Service Bulletin

Subject: CHECK ENGINE LIGHT ON WITH DTC P0191:00 OR P0192:00	Bulletin No: 01-010/14
	Last Issued: 04/29/2014

- This bulletin supersedes the previous bulletin 01-010/14 issued on 04/07/14 and 04/08/14. The DESCRIPTION has been revised.
- Changes are noted below beside the change bar in Red.

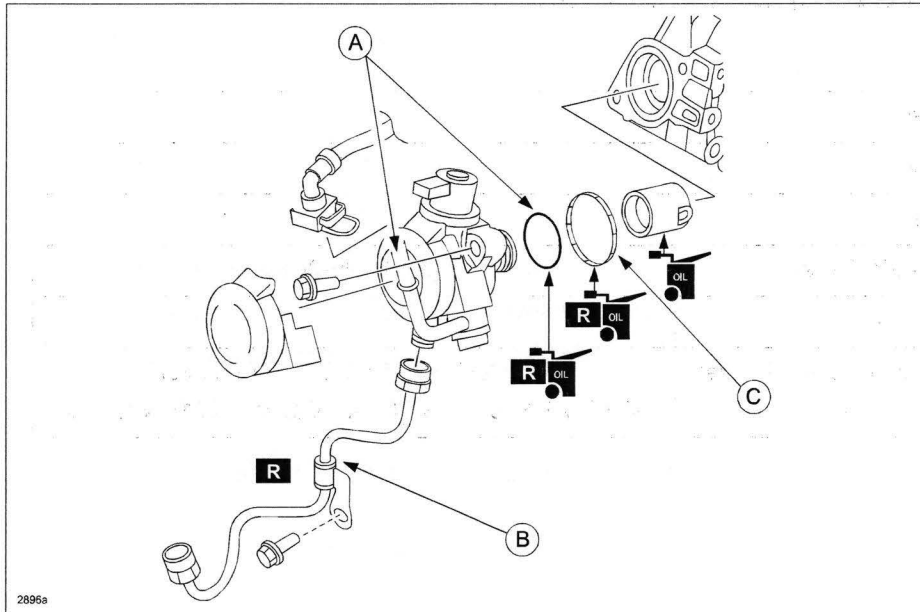
This is caused by the high pressure fuel pump not generating the target fuel pressure (due to a manufacturing error of the inner parts). To correct the problem, production control has been improved.

1. Verify customer concern.
2. Replace the high pressure fuel pump with a modified one according to the Workshop Manual.
3. Replace the high pressure fuel pump (A: fuel pump; B: fuel pipe; C: rubber seal) with a modified one according to the instructions on MS3 online or the Workshop Manual (section 01-14 HIGH PRESSURE FUEL PUMP REMOVAL/INSTALLATION).
